# Memorandum

Subject: Kinsale Area Fields – Decommissioning Plan  
– Consent Application No. 2, Technical Review

**Figure 1** Example of an 'external' diamond wire cutter

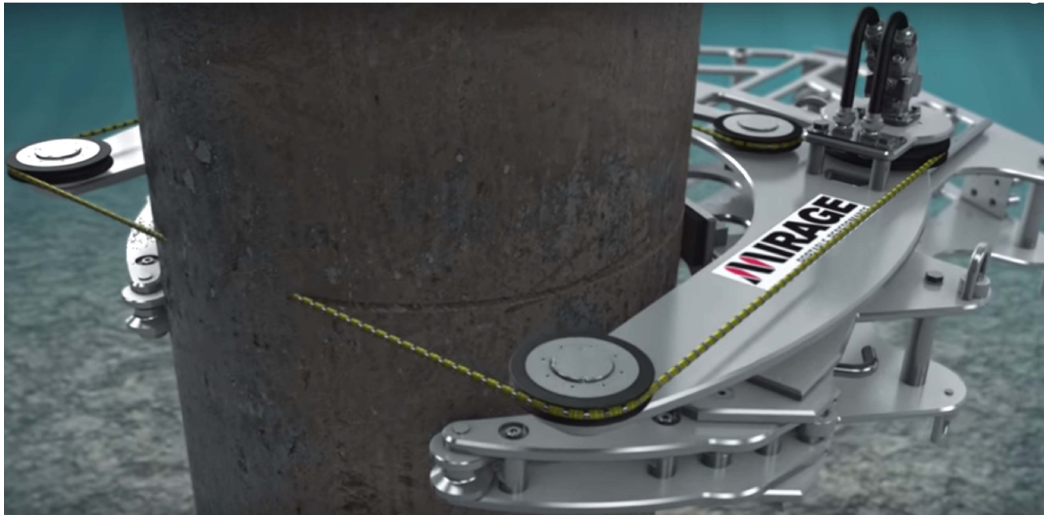
KEL describes two methods for achieving the jacket leg cuts (external diamond wire, or internal pipe cutting techniques – examples of both types are illustrated in Figures 1-3 below). KEL has since stated that surveys of the legs have revealed that only 5 of the 16 leg internal are clear of obstruction to permit internal cutting 'below the seabed'. The

remaining 11 have grout or other internal obstructions that would prevent this. However, KEL has confirmed its intention to excavate around these 11 legs in order to achieve an external cut, also 'below the seabed level'. KEL acknowledges that the seabed around the Kinsale platform is 'hard' and excavation may be challenging. This may limit the depth to which a practical cut can be achieved and so, not unreasonably, KEL is reluctant to commit to a specific depth at which an external cut would be achieved. Providing any cut is 'below the seabed' KEL will be compliant with the requirements of OSPAR Decision 98/3.
